CITY OF GLENDALE, CA

DESIGN REVIEW STAFF REPORT – SINGLE FAMILY

| September 4, 2023 <i>Decision Date</i> | 1733 Don Carlos Avenue <i>Address</i> |
| PADR-001318-2023 <i>Case Number</i> | Timothy Clark <i>Applicant</i> |

TITLE:
PROPOSED SITE PLAN, ROOF PLAN, & SECTIONS

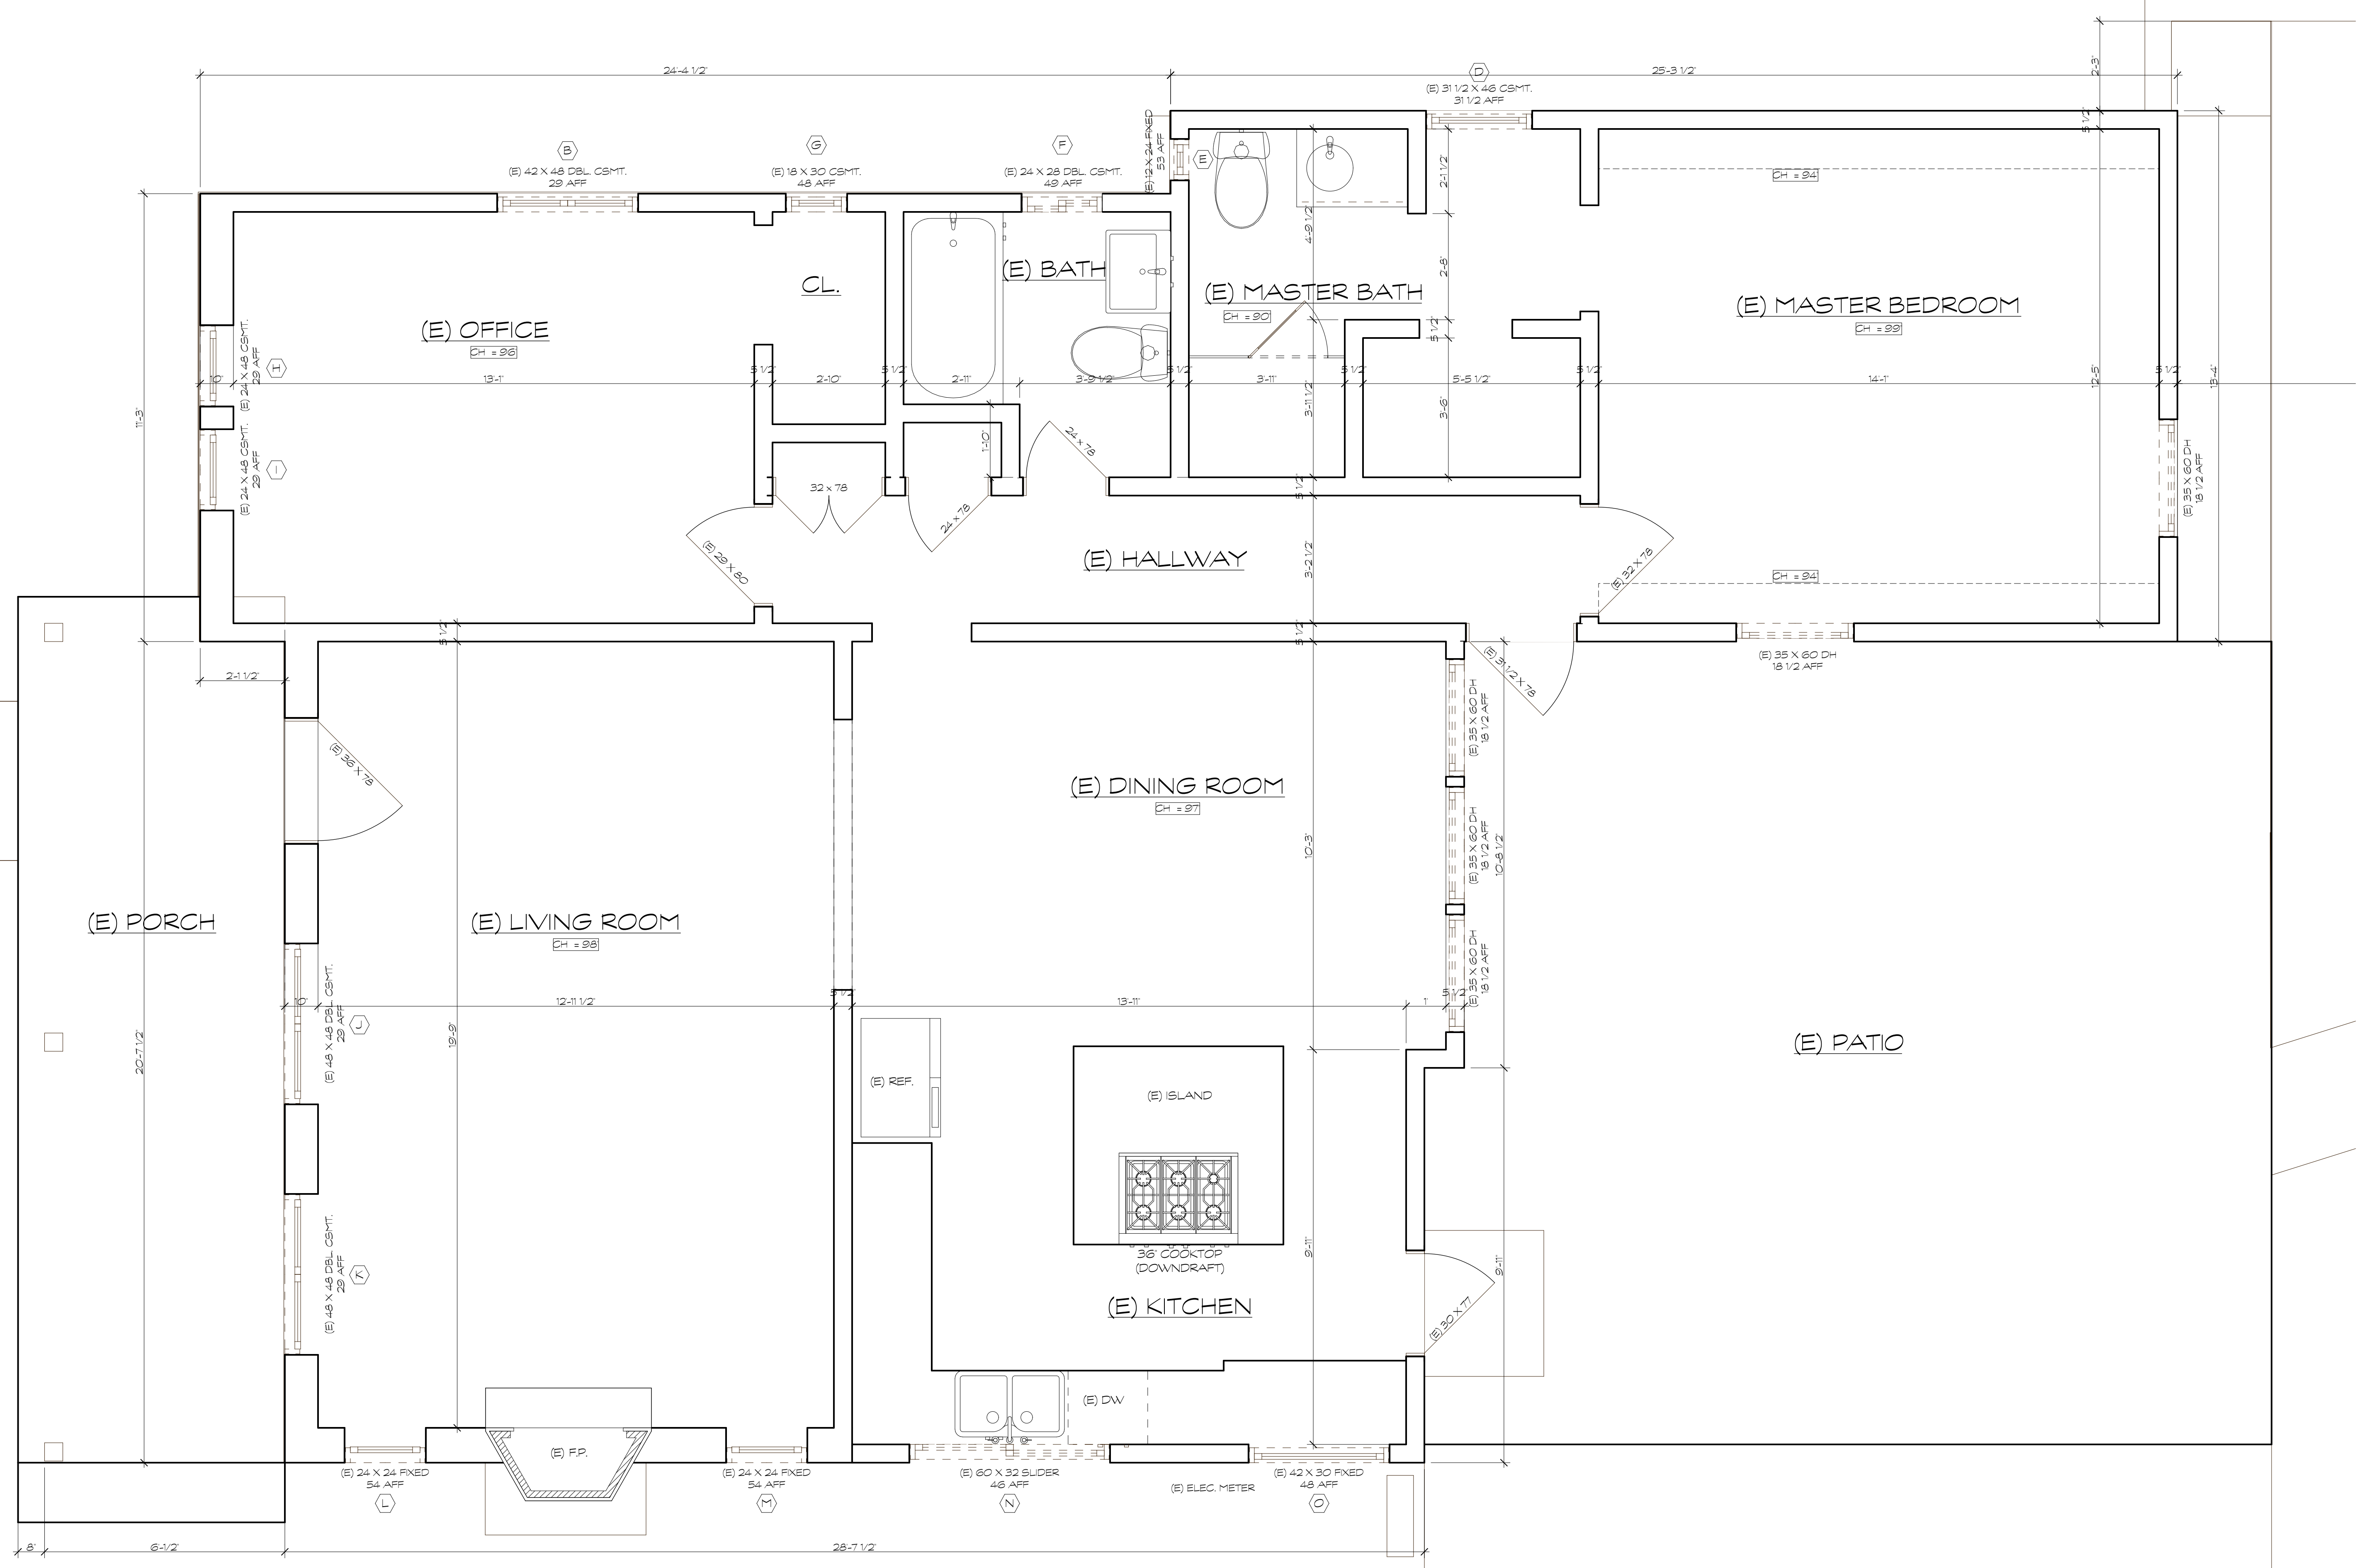
The owner was recently instructed, after the submittal date of the included plan, to add the note "Protected oak, sycamore, bay trees or City street trees on the property and within 20' of the property are inaccessible to the proposed construction activity and will experience NO impact. No protective fencing is required" to the project site plan.
